**TOWN OF NEWBURGH
PLANNING BOARD
TECHNICAL REVIEW COMMENTS**

PROJECT: ALDI EXPANSION
PROJECT NO.: 18-06
PROJECT LOCATION: SECTION 97, BLOCK 1, LOT 2
REVIEW DATE: 31 MAY 2018
MEETING DATE: 7 JUNE 2018
PROJECT REPRESENTATIVE: APD ENGINEERING

County Reply – Mandatory Review of Local Planning Action as per NYS General Municipal Law §239-l, m, & n

Local Referring Board: Town of Newburgh Planning Board **Referral ID #:** NBT 15-18M
Applicant: ALDI, Inc. **Tax Map #:** 97-1-2
Project Name: Aldi Building Addition **Local File #:** 2018-06
Proposed Action: Site Plan for addition to existing building for storage
Reason for County Review: Within 500 feet of NYS Route 17K
Date of Full Statement: May 4, 2018

SITE PLAN	
Drawing Name:	
Date: 4/2/18	Project No. 18-0209C
Type: PRELIMINARY /FINAL	
Drawn By: SGC	C 2
Scale: 1"=30'	Drawing No.

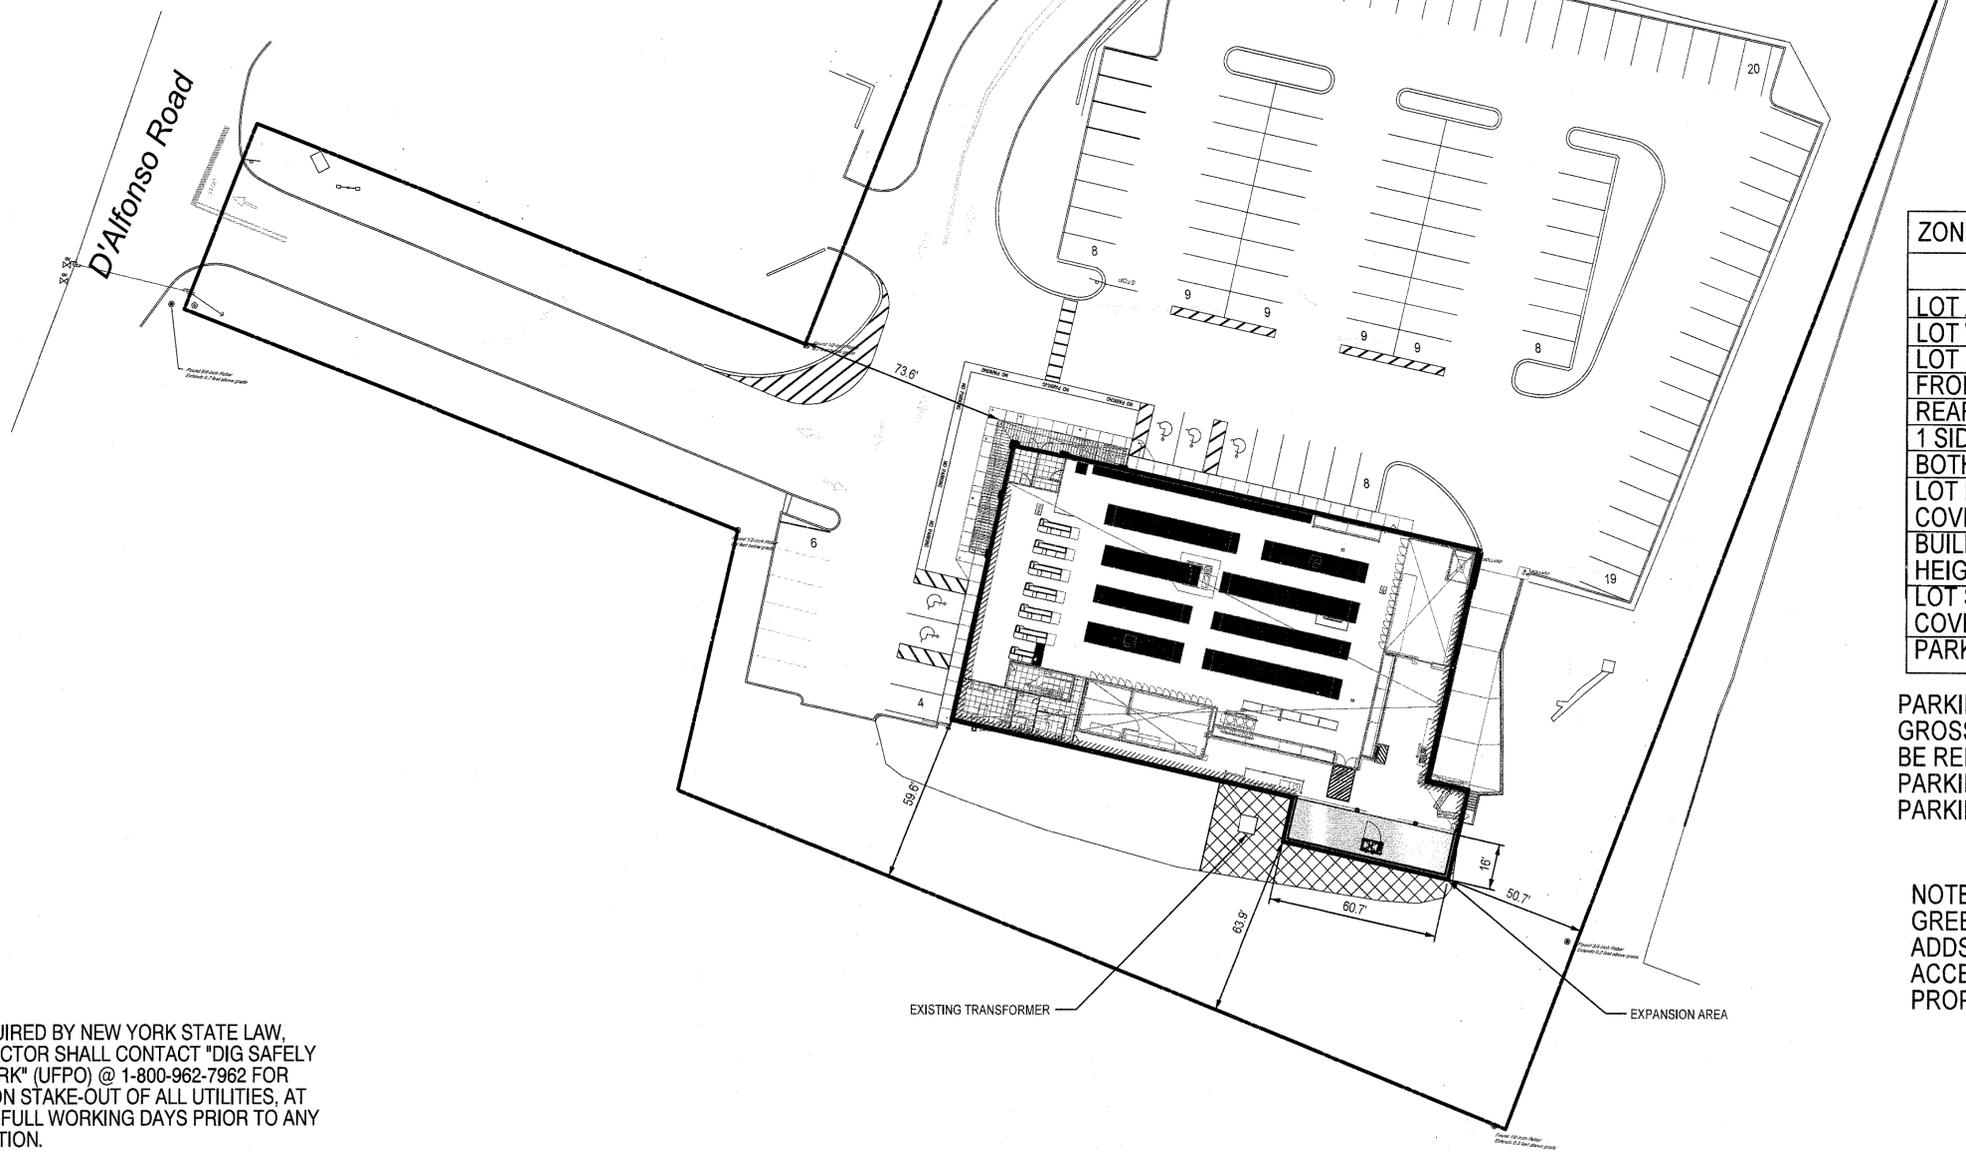
Green Infrastructure/Runoff Reduction: The applicant proposes to locate the building addition on an area of the site currently covered in gravel, to restrict the gravel coverage to the minimum area needed for the loading zone, and to replace the additional existing graveled area with lawn and other plantings. We encourage and support all these actions. Because the site is steep going down to Route 17K and D'Alfonso Road, we advise the Town that additional measures to retain stormwater onsite may be necessary. These could include disconnected downspouts, bioretention areas to the rear of the building or along the driveways as drainage swales, or other measures as appropriate.

Side Yard Setbacks: The proposed addition is very close to the allowed side yard setback. We advise the Town to have the applicant provide an accurate survey to their construction team to ensure that setbacks are maintained.
